***1.2 - RECOMMENDATION TO WAPC - KELMSCOTT DISTRICT CENTRE
PRECINCT STRUCTURE PLAN***

WARD : RIVER
FILE No. : M/688/22
DATE : 16 February 2023
REF : AV
RESPONSIBLE : EDDS
MANAGER
APPLICANT : City of Armadale
LANDOWNER : Various
SUBJECT : Various -
LAND Kelmscott District
Centre
ZONING
MRS / : Various
TPS No.4 : Various

Kelmscott District Centre Precinct Structure Plan

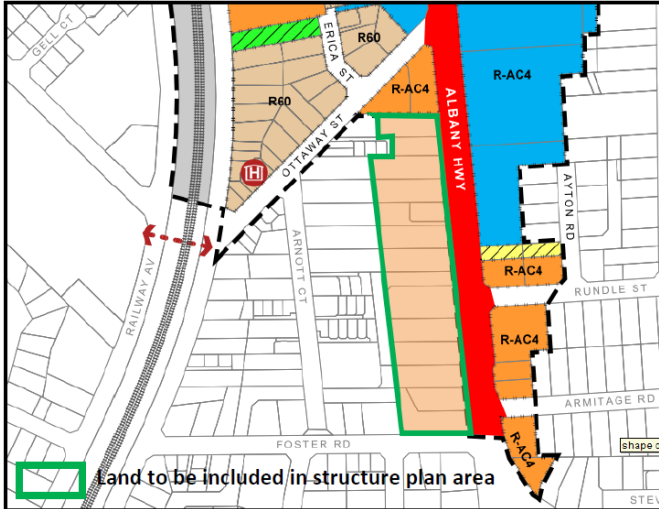
| SCHEDULE OF SUBMISSIONS PROPOSED PRECINCT STRUCTURE PLAN KELMSCOTT DISTRICT CENTRE (PLU/PS4/11/2) | | | | |
|--|-----------|--------------------------|--|---|
| | | | <p>Scheme No. 4. It will be requested in subsequent sections of this submission that the land identified in Figure 3 be included within the structure plan area.</p>  <p>Figure 3.</p> <p>Purpose of Submission:</p> <p>21.1 The purpose of this submission is to provide comment on the proposed structure plan and request that the structure plan boundary be modified to include the land identified in Figure 3. As part of including this land we would also seek its inclusion into the Southern Mixed-Use Transition sub-precinct with a land use zoning of 'Mixed Use Residential', consistent with the other properties included within the sub-precinct. We consider this to</p> | <ul style="list-style-type: none"> 21.1: Not Supported. Refer to discussion in report. The City selected the proposed Precinct Structure Plan boundaries on the basis of existing District Centre zoning with some inclusion of residential zoning north of Ottawa Street and special residential zoning east of the Canning River. It |

| SCHEDULE OF SUBMISSIONS PROPOSED PRECINCT STRUCTURE PLAN KELMSCOTT DISTRICT CENTRE (PLU/PS4/11/2) | | | | |
|--|-----------|--------------------------------|---|--|
| | | | <p>be an appropriate and warranted modification to the structure plan for the following reasons:</p> <p>21.2 It will improve the ability for the ‘Southern Mixed-Use Transition’ sub-precinct to deliver on the vision of being a <i>‘gateway’ environment into the Town Centre Precinct</i> from the south. At present, only the eastern side of Albany Highway has been included in the structure plan area with the subject site and the land identified in Figure 3 remaining in the ‘Residential’ zone with a proposed density of R15/60 (subject to the approval of Scheme Amendment 89).</p> <p>This inconsistency in zoning will undoubtedly result in inconsistent development outcomes on each side of Albany Highway with the eastern side likely to be dominated by commercial development and land uses that benefit from the high traffic environment along Albany Highway. In comparison, the western side of Albany Highway will be characterised by residential development, or no development at all in the short term should market dynamics remain as they are currently. This will jeopardize the ability to deliver a ‘gateway’ environment and reduce the legibility of the district centre with visitors likely to be unclear on where the precinct starts and finishes.</p> <p>Including the subject site and land identified in Figure 3 would enable consistent development outcomes that would be likely to result in an improved entry statement into the district centre.</p> <p>21.3 Exclusion of the land identified in Figure 3 from the structure plan area doesn’t appear to be consistent with the methodology applied to determine where the structure plan boundary should be as:</p> | <p>should be acknowledged that modelling of the existing District Centre zone extents demonstrates that target residential yields and suitable levels of commercial floorspace will be met. The Precinct Structure Plan especially emphasises more intensive development outcomes in the core of the District Centre rather than ‘frame’ areas. In this regard identification of the requested area as ‘Mixed Use Residential’ and inclusion in the Structure Plan boundary is not supported.</p> <ul style="list-style-type: none"> • 21.2: Not supported. Refer to report. The existing proposed ‘Commercial’ and ‘Mixed Use Residential’ land use zones within the Precinct Structure Plan area function as a gateway to the ‘Mixed Use Retail Core’ of the District Centre. The state and local planning framework (e.g. Residential Design Codes, Apartment Design Codes, Town Planning Scheme No.4 and Local Planning Policies) already encourage high quality development outcomes in the proposed extension area. • 21.3: Not supported. Refer to report. Dwelling yields are one component of |
